Product information - BMW brake pads | HELLA

BMW brake pads

8DB 355 009-271 / 8DB 355 015-391

New allocation of the brake pads

Mounting instructions

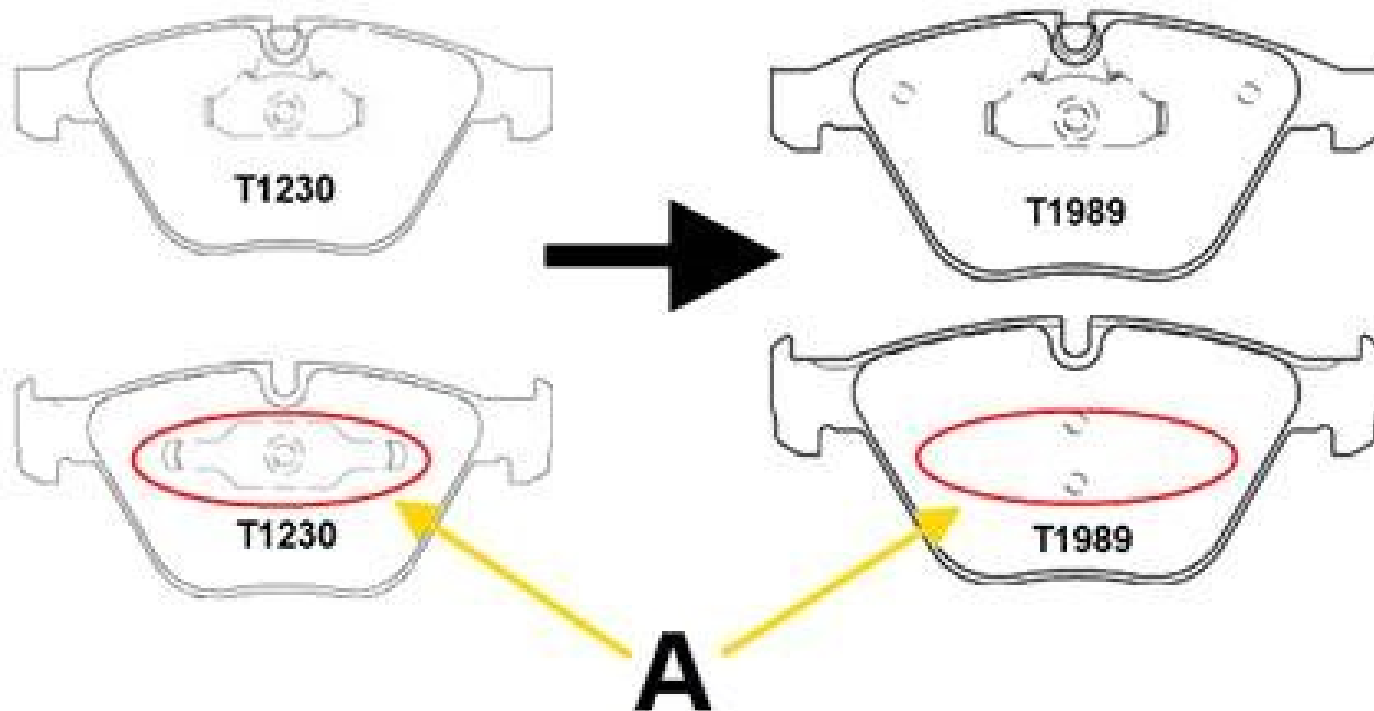
The difference between both brake pads is the missing retaining spring (A) on the brake pad 8DB 355 015-391 / T1989 on the fist side.

All other models are now covered by 8DB 355 015-391 / T1989. 8DB 355 015-391 / T1989 can also be retroactively used for all vehicles linked.
